SUNNINGDALE PARISH COUNCIL

21/01451/FULL: Land At 9 Sunning Avenue Sunningdale Ascot

1x new detached dwelling to include bin and cycle storage, removal of existing trees, replanting of proposed trees and all associated works following demolition to existing garage.

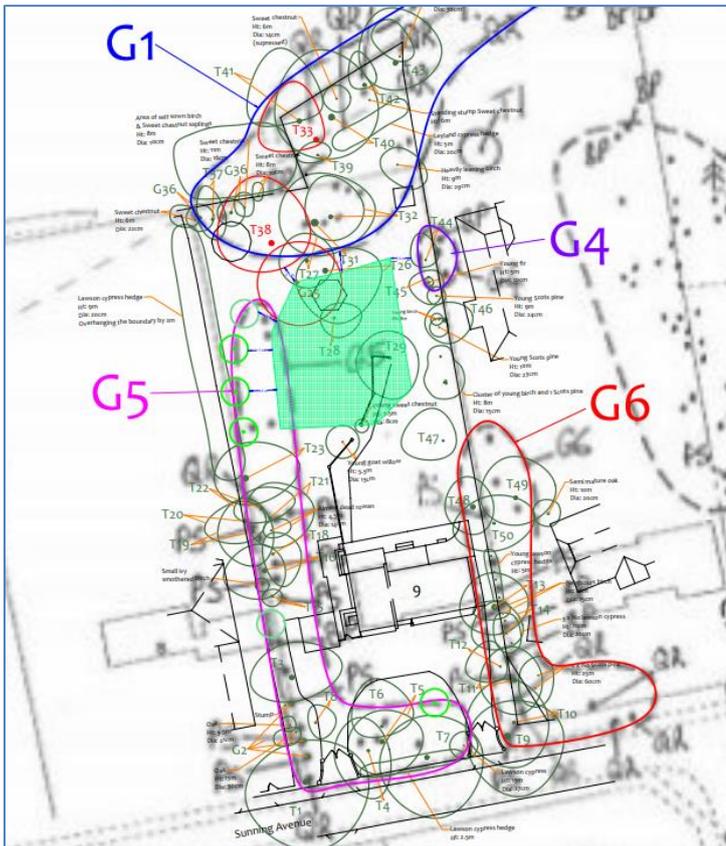
Replanting trees within the area of G1 and especially G5 (shown in the diagram below) would be problematic regarding the siting of the proposed property. Hence, it would appear that the current application has chosen to largely ignore this RBWM recommendation from 19/01407.

Impact on trees- centre of plot

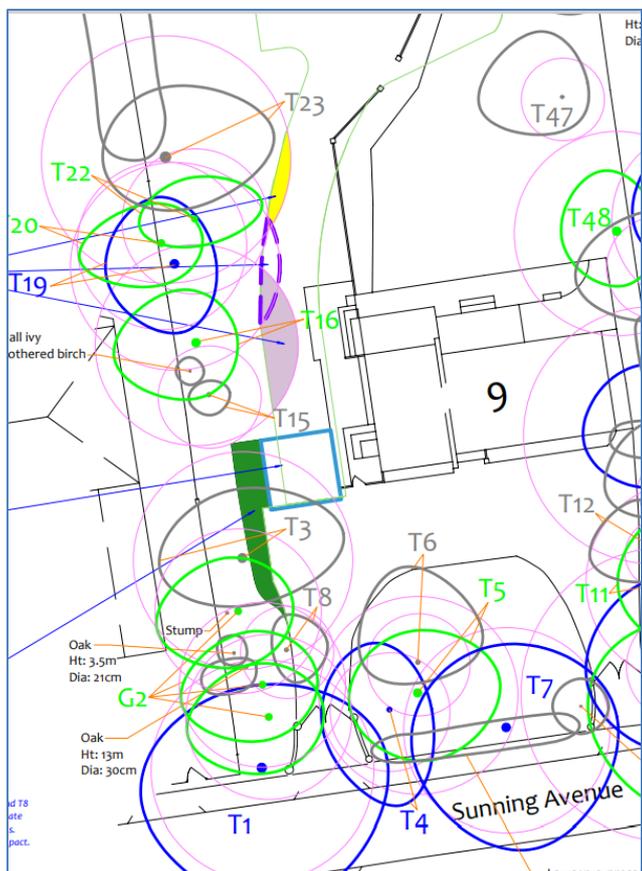
In the centre of the plot the proposed new access drive to the property also impacts on the RPA of TPO trees within Group G5 as shown in the chart below. 11% of the RPA of T16, 4% of the RPA T19 and 2% of the RPA T23 are all affected by the new surface.
